Extending Power via MDI for IEEE 802.3BT, BASELINE

Purpose

To extend the existing PoE TLV to encompass IEEE 802.3BT additions.

79.3.2 Power Via MDI TLV

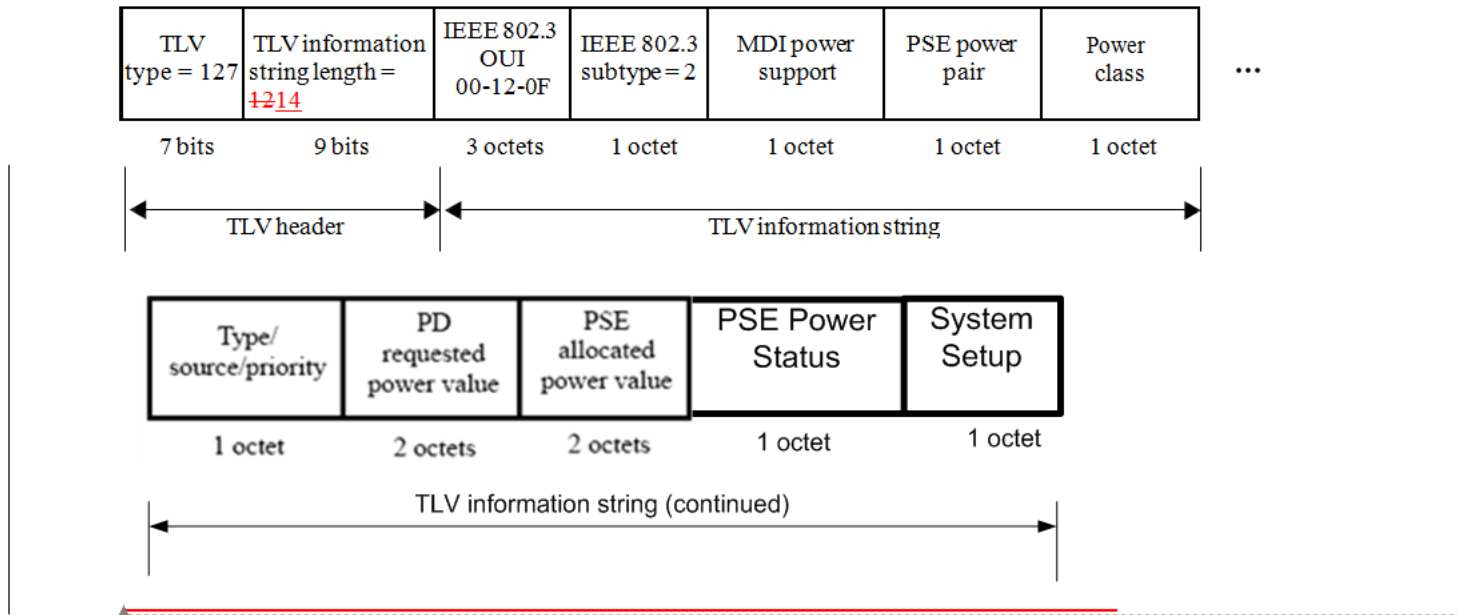
[TLV length changed from 12 to 14 and two more octets were added.]
